POUR ZONE No. 105 FLOW DIAGRAM 1-5114A
 REQUIRED COMPLETION DATE QSL
 FABRICATED BY TUBECO WELD PROCEDURE

LIVSEY & COMPANY, INC.
 DONALD C. COOK NUCLEAR PLANT

DWN JG DATE 3-24-74 CONTAINMENT VICINITY
 CRD GN DATE 10-5-71 DWG. NO.
 ISSUED 1-NSW-51 REV. 5
 REF DWG. 1-5497A

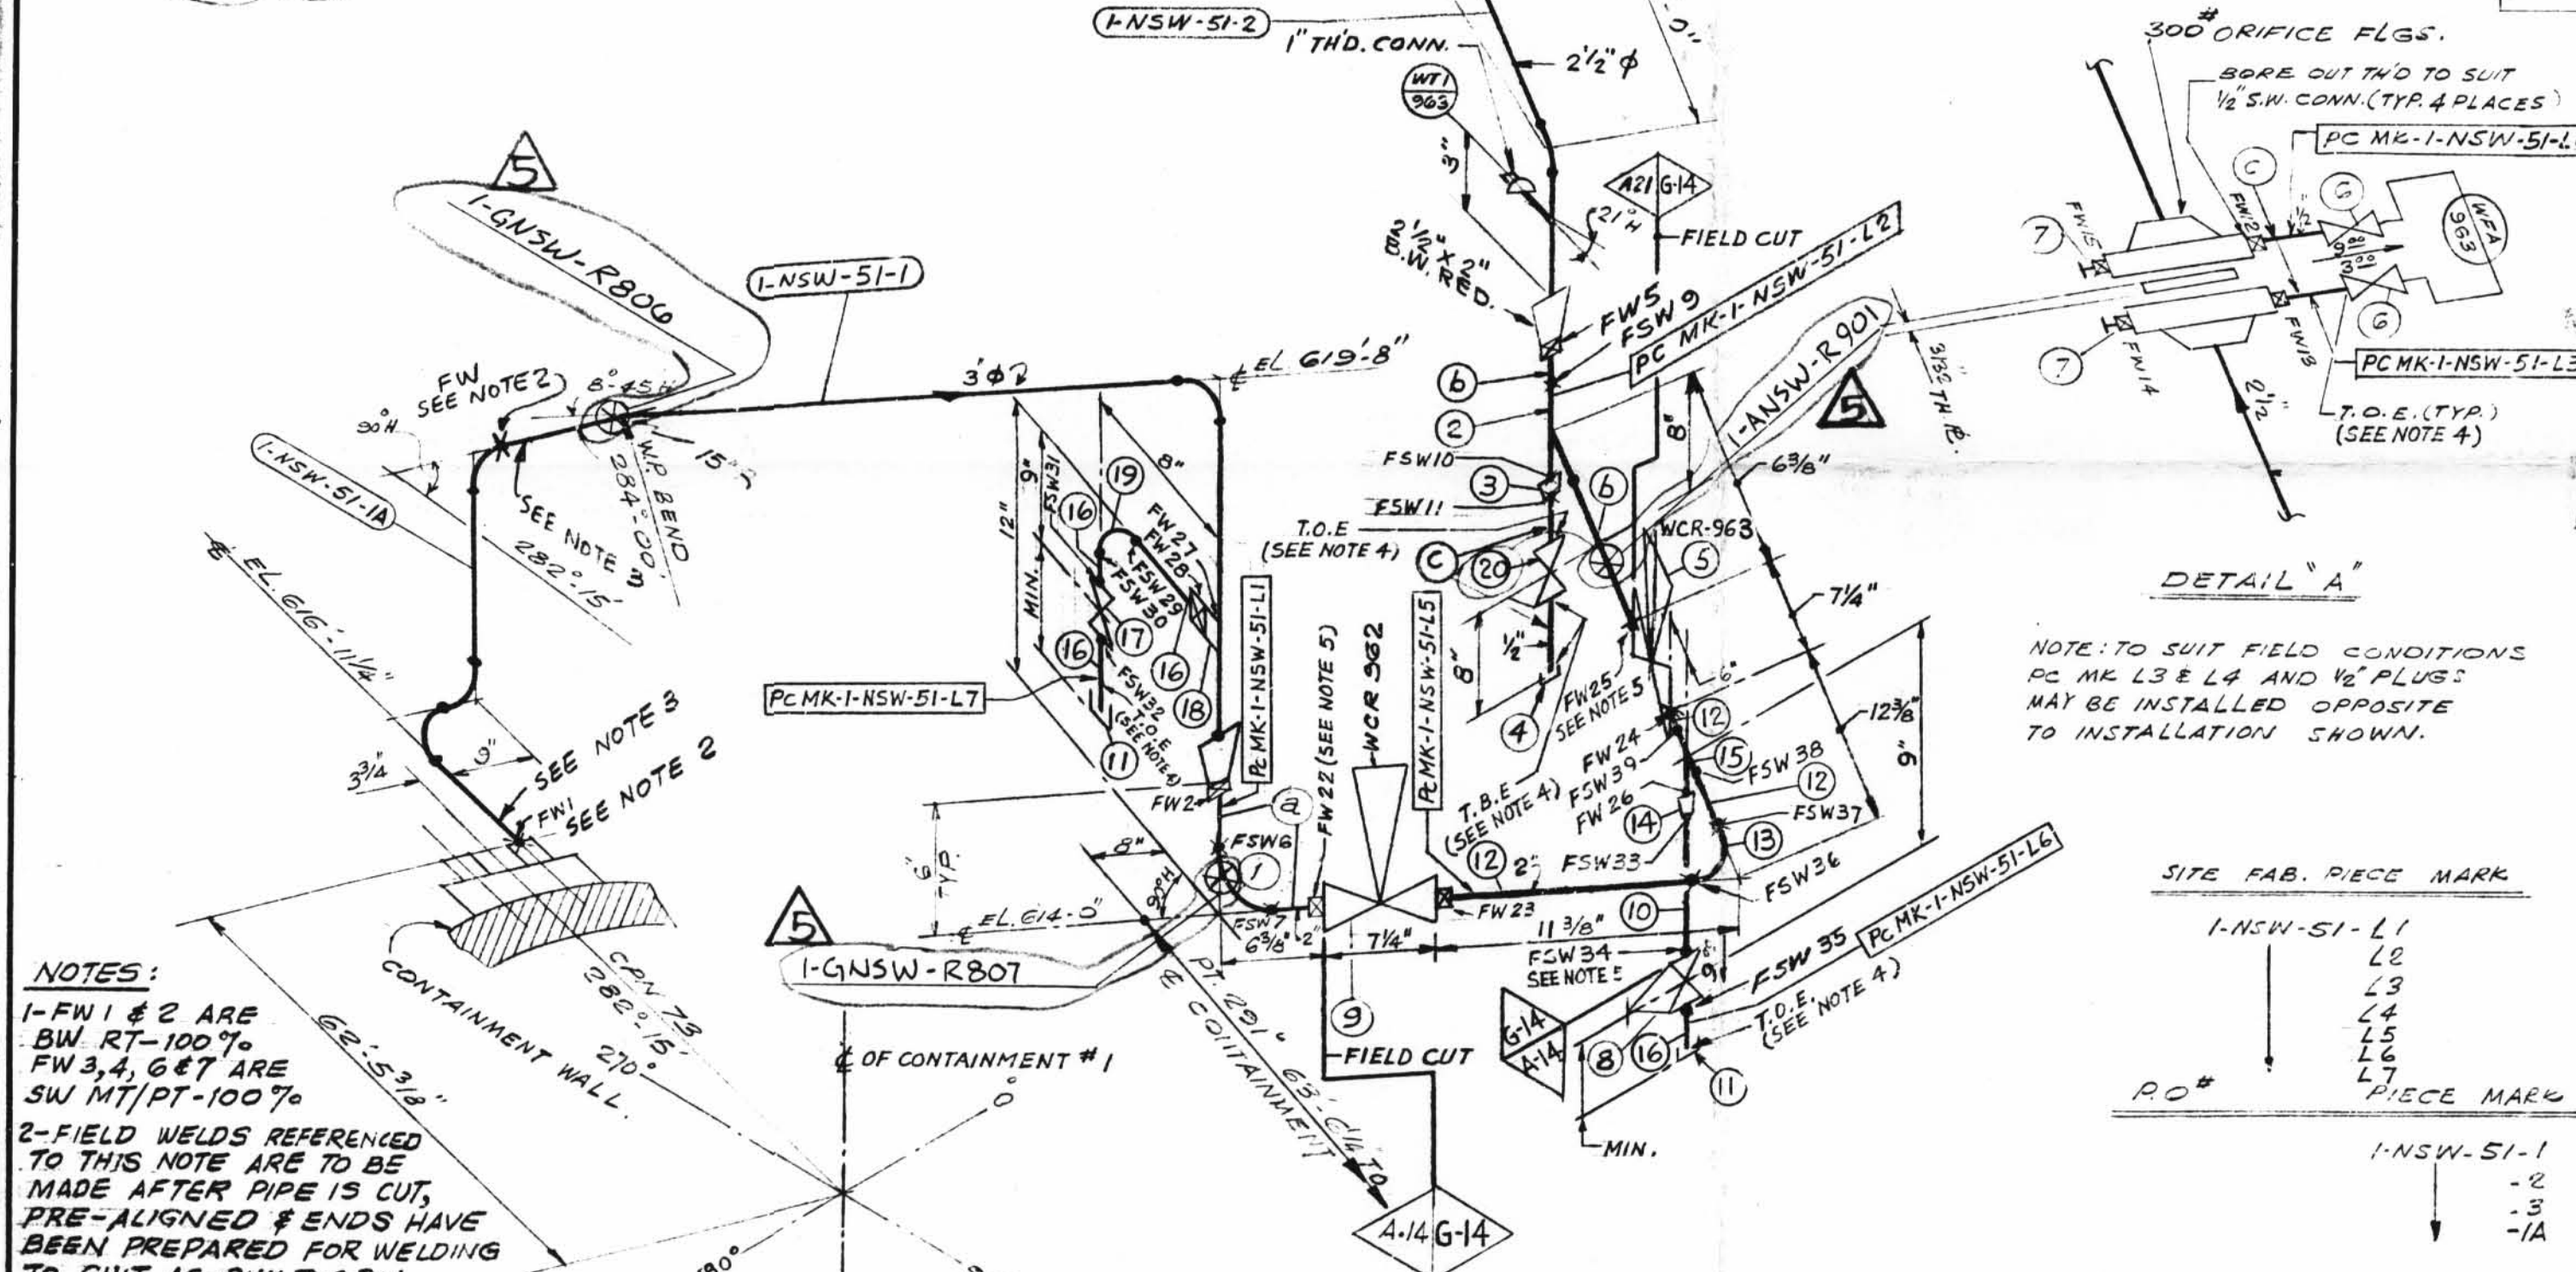
REV	DATE	DR	DESCRIPTION	REMARKS
1	10/14/72	I.F.	REVISED BY NPS DESIGNS: REMOVED HOLD ON PC MK 1-NSW-51-1, ADDED: PC MK 1-NSW-51-1A, NOTES 283, FWS PER DWG. 1-5497A REVISION 5	FIELD ACTION REQ'D
2	10/16/72	N.M.	REVISED BY A.E.P. DESIGN PER RFC-DC-12-671 TO REFLECT AS BUILT WHEN CONTROL VALVE WAS ADDED	NO FIELD ACTION REQ'D
3	11/3/72	WT	PER RFC-DC-12-2549, ADDED: PIPE SPEC. G-14, DIMS. 1, PC MK L5, L6 & L7, WELD BOX NOTES 5, 6 & 7, FIELD WELDS FW 22 TO 28, FSW 29 TO 39 & ITEMS 9 TO 19 TO B/M, REVISED ITEM NOS. 4 & 5 IN B/M, DIM. 11 3/8 WAS 10 3/8, ADDED 20 1/4.	FIELD ACTION REQ'D
4	11/16/72	JM	PER RFC-DC-12-2549 ITEMS 10 & 12 WERE SCH. 40S PIPE	FIELD ACTION REQ'D
5	8/1/73	DW	PER RFC-DC-12-2876 REV'D ITEM 10 QTY 3 TO 2, ADDED ITEM 20 AND SUPPORT MARK NOS. SUPERSEDED HGR 150 1-GNSW-51, ALL ABOVE TO REFLECT AS-BUILT CONDITIONS.	NO FIELD ACTION REQ'D
